STAFF RECOMMENDATION
1710 Linden Avenue
December 16, 2020

Application: New Construction—Addition; Setback Determination
District: Belmont-Hillsboro Neighborhood Conservation Zoning Overlay
Council District: 18
Base Zoning: R8
Map and Parcel Number: 104160158
Applicant: Allard-Ward Architects
Project Lead: Jenny Warren, jenny.warren@nashville.gov

<p>Description of Project: This application is for a rear addition and a setback determination.</p> <p>Recommendation Summary: Staff recommends approval with the following conditions:</p> <ol style="list-style-type: none">1. Staff approve the final windows, doors, brick, and roof color prior to purchase and installation; and2. The HVAC shall be located behind the house or on either side, beyond the mid-point of the house. <p>With these conditions, staff finds that the application meets Sections II.B and V of the design guidelines for the Belmont-Hillsboro Neighborhood Conservation Zoning Overlay.</p>	<p>Attachments</p> <ul style="list-style-type: none">A: PhotographsB: Site PlanC: ElevationsD: Floor Plans
--	--

Figure 1: 1710 Linden Avenue.

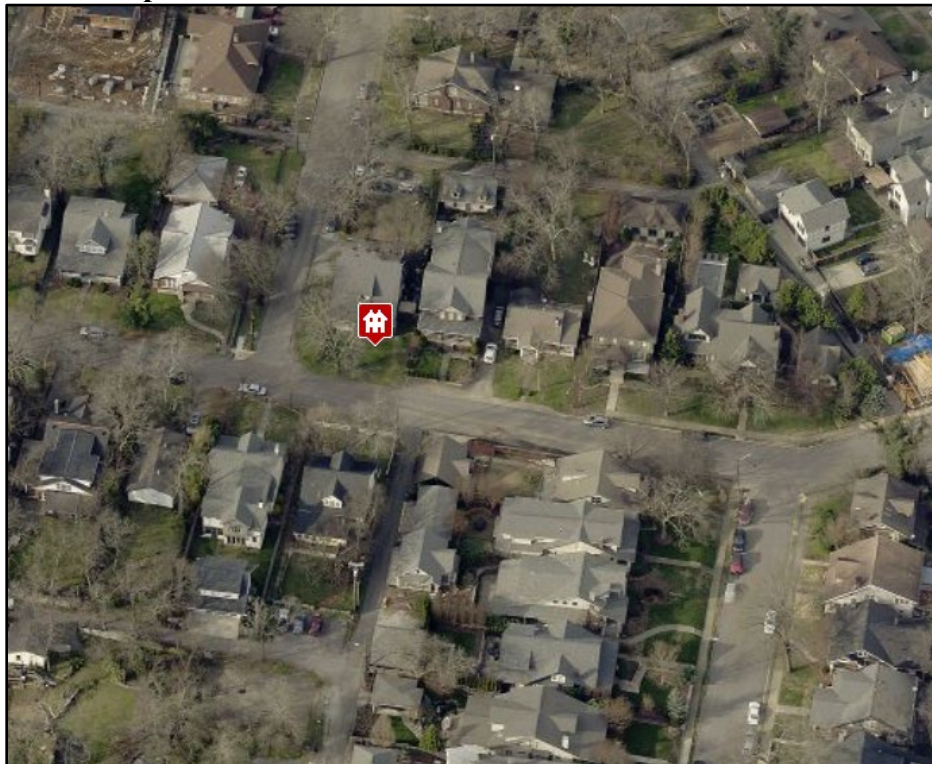
Background: 1710 Linden Avenue is a c. 1920 bungalow that contributes to the Belmont-Hillsboro Neighborhood Conservation Zoning Overlay (Figure 1).

Figure 2: Roof plan showing proposed rear addition and insets.

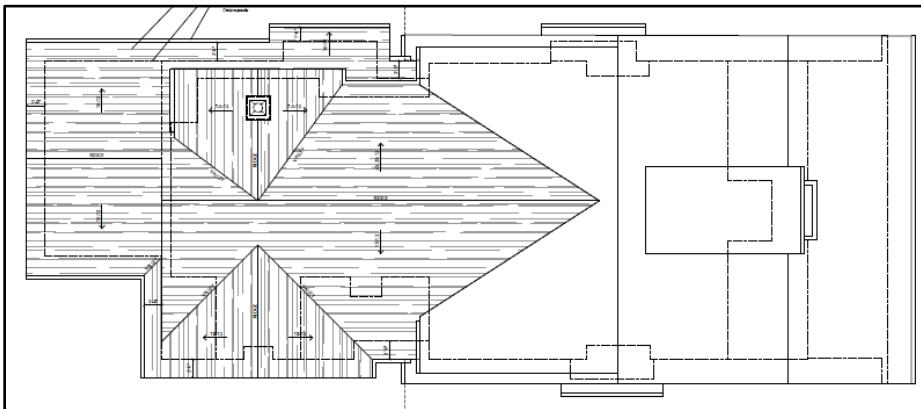
The proposed addition will tie into the historic roof about eight inches (8”) below the original ridge line and will not rise any taller. On the ground level, the addition is inset two feet (2’) on either side where it ties into the house and then after six feet (6’) on the right and eight feet (8’) on the left, it steps out to be flush with the historic side walls on both sides. The second floor is inset even further.

Excluding the rear deck, the existing footprint of the house is about one-thousand-seven-hundred, nineteen (1,719) square feet. The proposed addition will add approximately one-thousand-two-hundred-fifty-two (1,252) square feet of covered space to the existing footprint – not more than doubling the footprint.

Staff finds that the proposed addition meets Sections II.B.1.a. and b for height and scale.

Figure 3: Side elevation facing Oakland Avenue

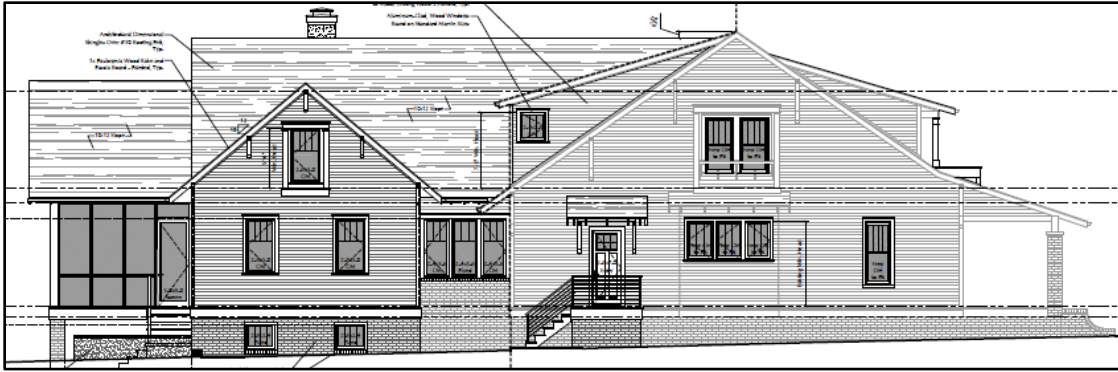
Design, Location & Removability: The location of the addition at the rear of the existing building is in accordance with the design guidelines. The addition’s inset, separate roof form, and lower height help to distinguish it from the historic house and to read as an addition to the house. At the same time, the scale, materials, roof form, and fenestration pattern are all compatible with the historic character of the existing house. The addition is designed so that if it were to be removed in the future, the historic character of the house would still be intact. Staff finds that the project meets Sections II.B.2.a e and f.

Figure 4: Site plan

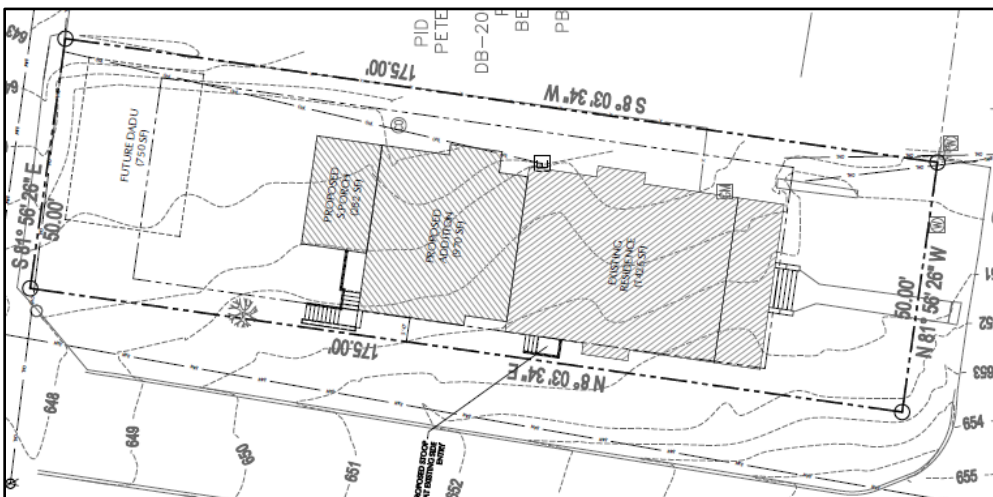
Setback & Rhythm of Spacing: The front setback will not be impacted by the work. The addition will be five feet (5’) from the interior side (right) property line at the closest point. On the Oakland Avenue side, the proposed addition requires a setback determination. The base zoning setback required for the side street is ten feet (10’). The new addition will be about five feet (5’) from the property line – this matches the setback of the historic house. Since the proposed addition will step no closer to the property line than the historic house already does, staff recommends approval of this setback determination. The Commission has routinely approved similar setback determinations in the past, where an addition is flush with the historic house. The rear of the addition will be approximately fifty-two feet (52’) from the rear property line. Staff finds that the proposed addition meets Section II.B.1.c for setbacks.
